PROJECT: Centennial Addition and Remodel **PROJECT NO.** L13030
BID PACKAGE #2
ADDENDUM NO. 1 **DATE:** 5 AUG 2013

**CENTENNIAL
 ADDITION AND
 RENOVATION**

**BP2
 DEMOLITION
 SHEET**

D1.1

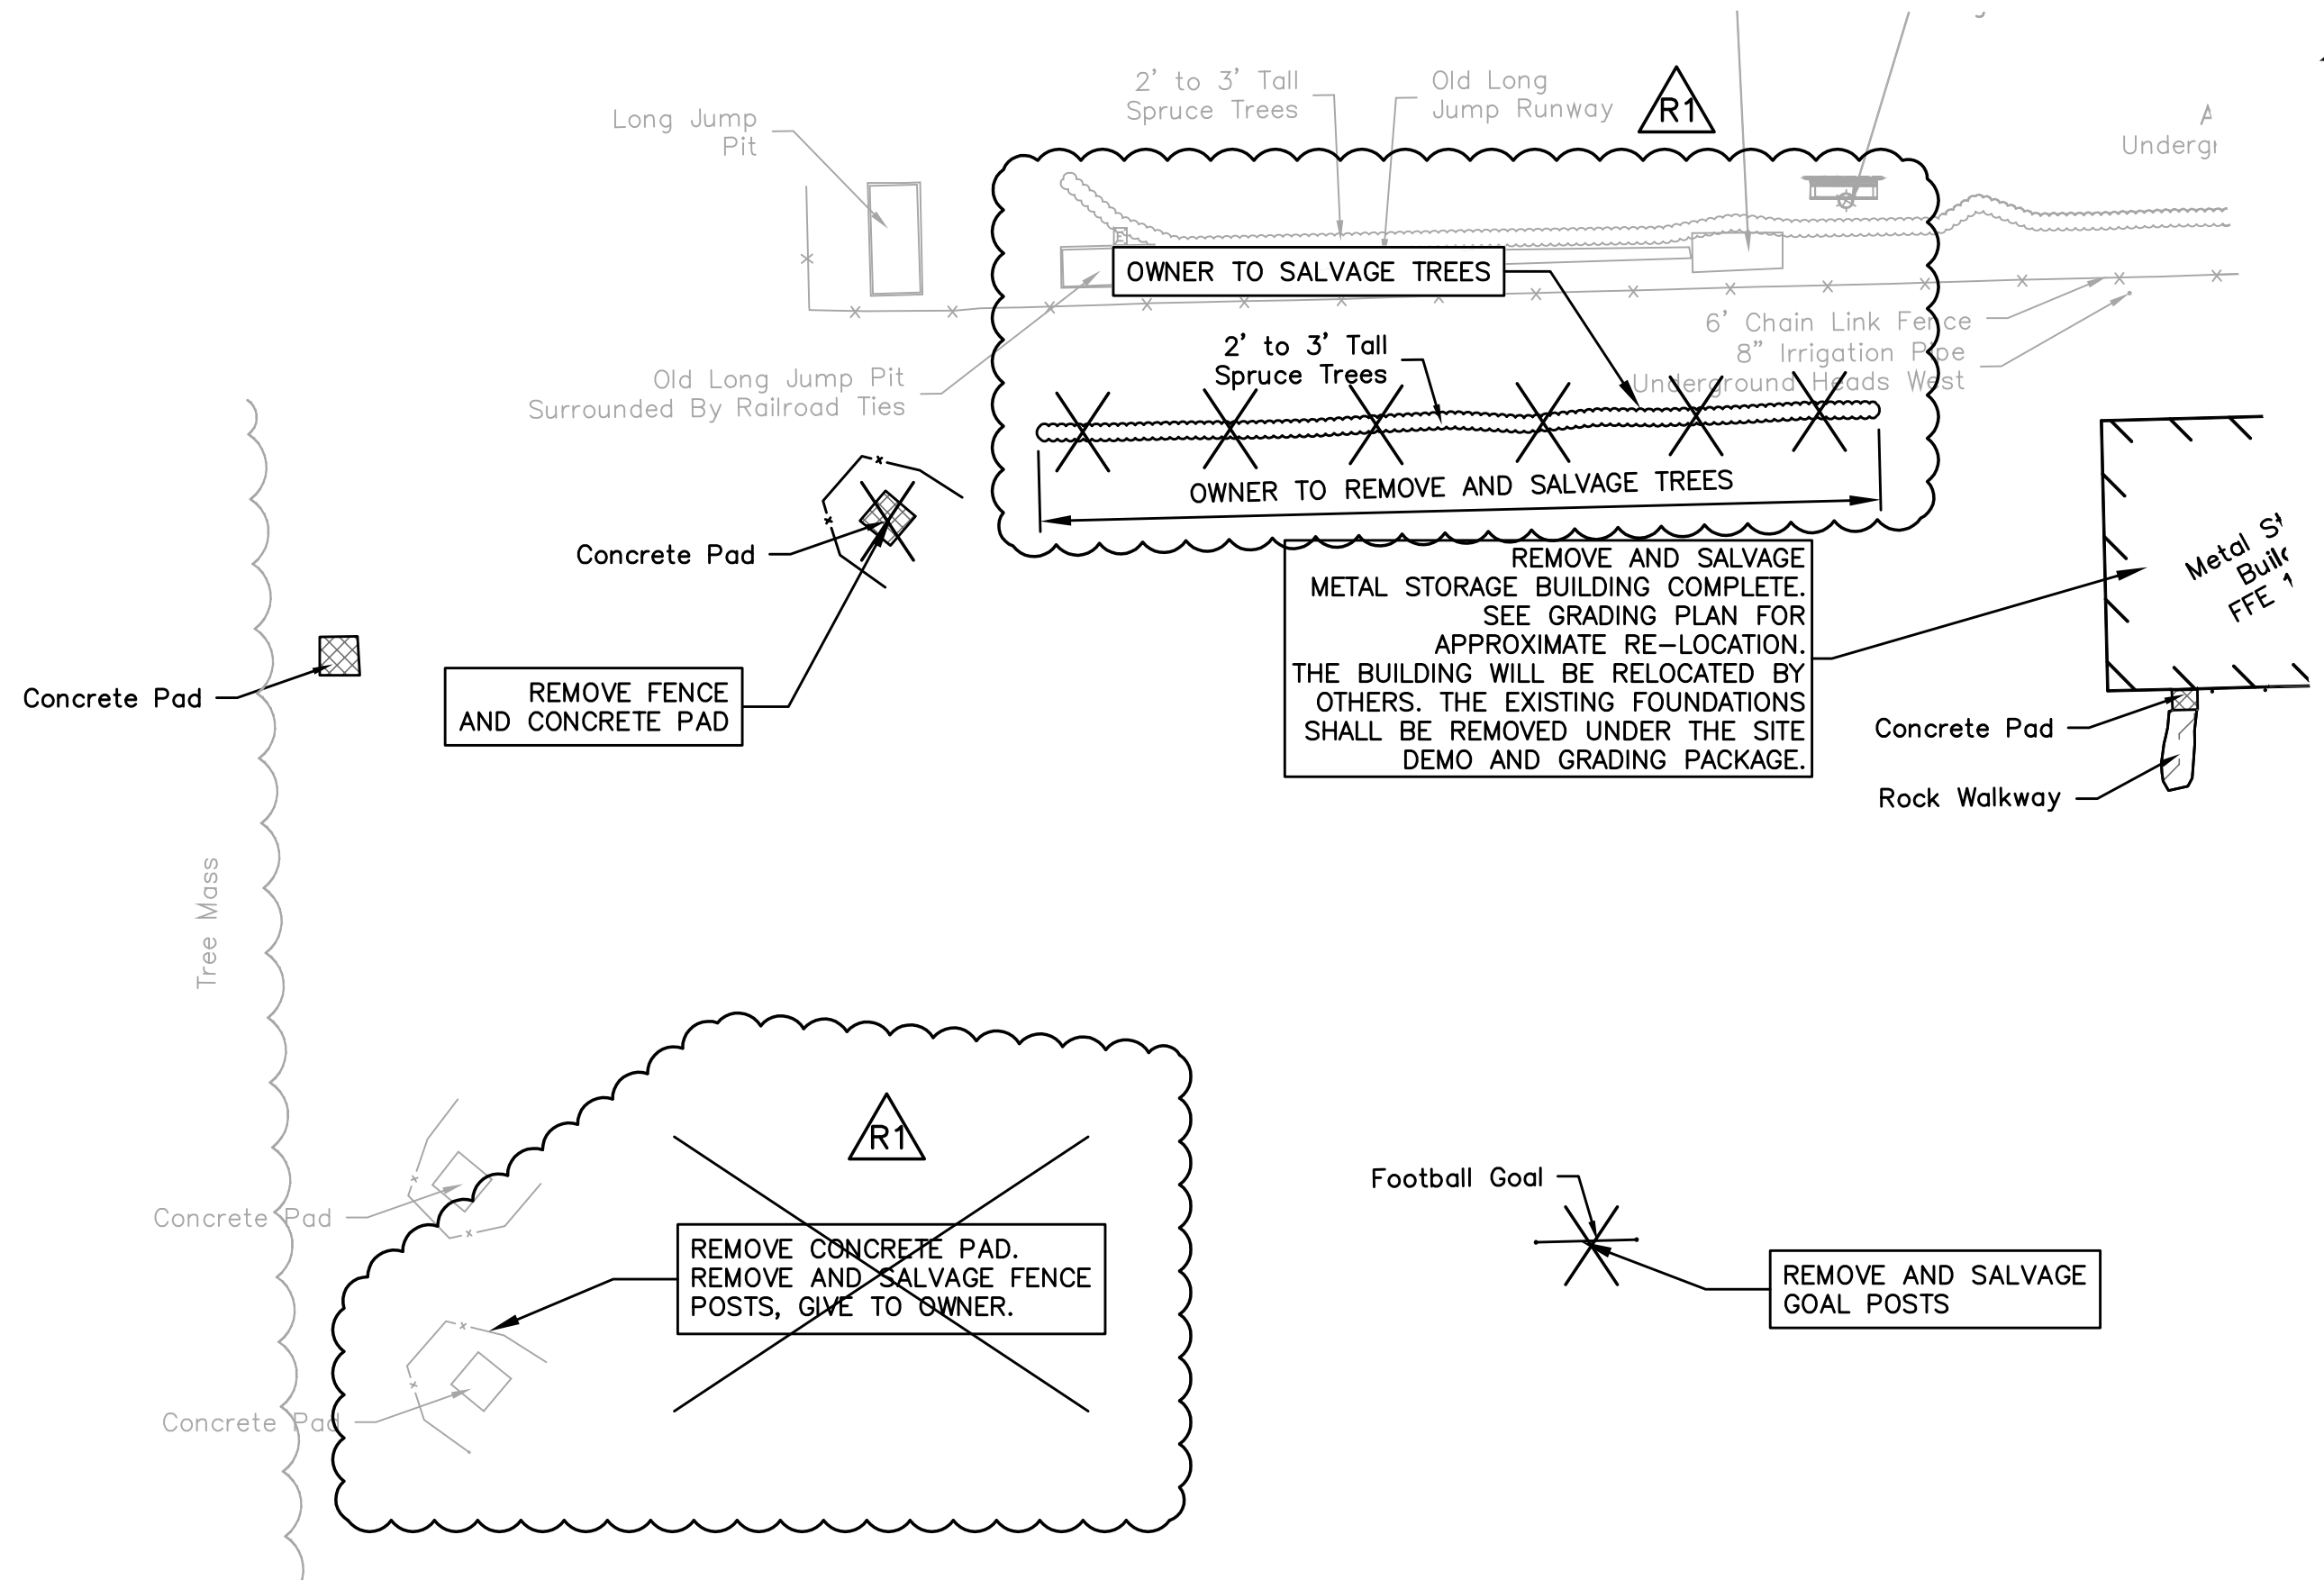
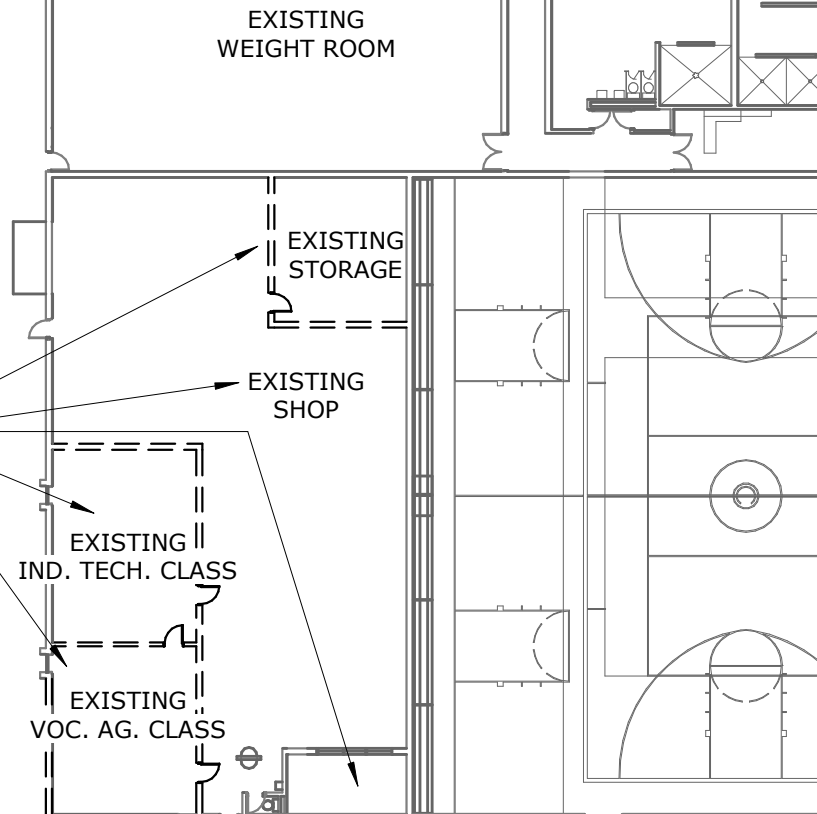
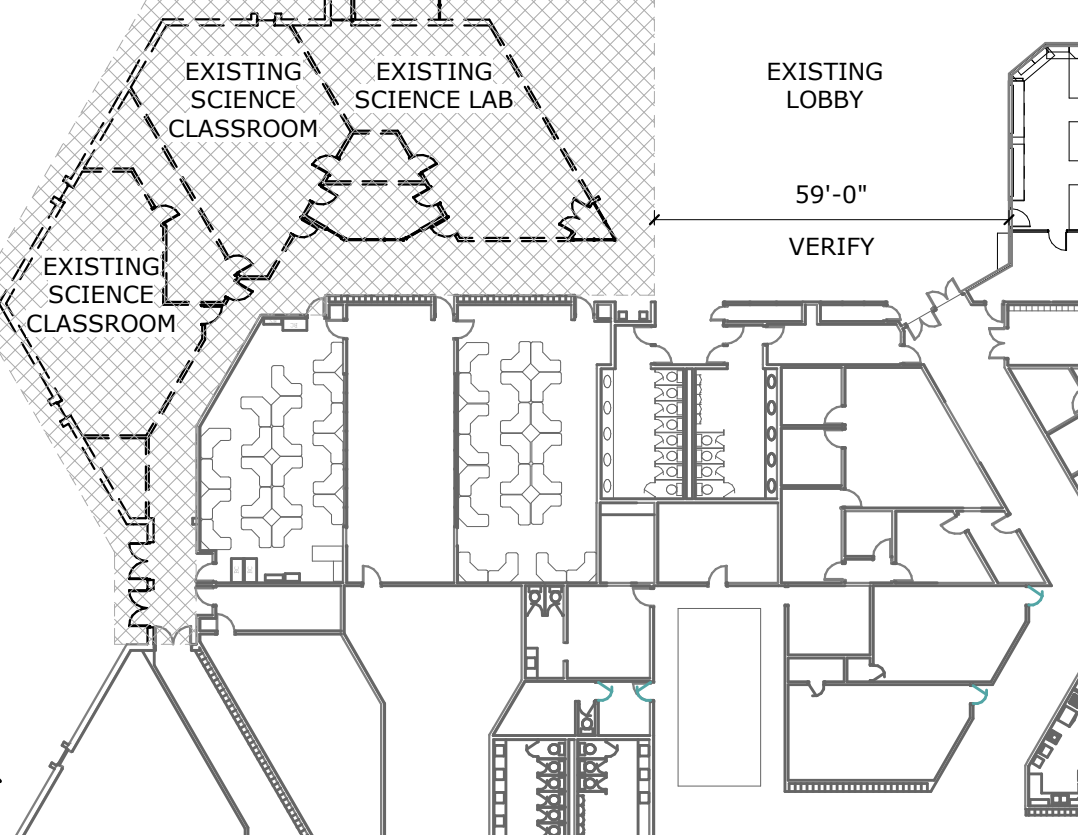
1. For building demolition see Sheet D1.1 included herein.
 - A. "[Click here & type Detail #]"
2. The attached Civil drawings shall revise or replace previously issues drawings;
 - B. Reference Sheet C1.1 with revisions to sheet C1.1.
 - C. Sheet C1.3R – Grading Overview Plan, replacement for sheet C1.3.

BUILDING STRUCTURE TO REMAIN
 INTACT, REMOVE INTERIOR WALLS,
 HVAC, ELECTRICAL, PLUMBING,
 FINISHES, ETC TO BUILDING SHELL
 AS SHOWN

BUILDING STRUCTURE AT THIS
 AREA TO BE REMOVED INCLUDING;
 FOOTINGS/FOUNDATIONS,
 SUPPORTING STRUCTURE, HVAC,
 ELECTRICAL, PLUMBING,
 FINISHES, ETC
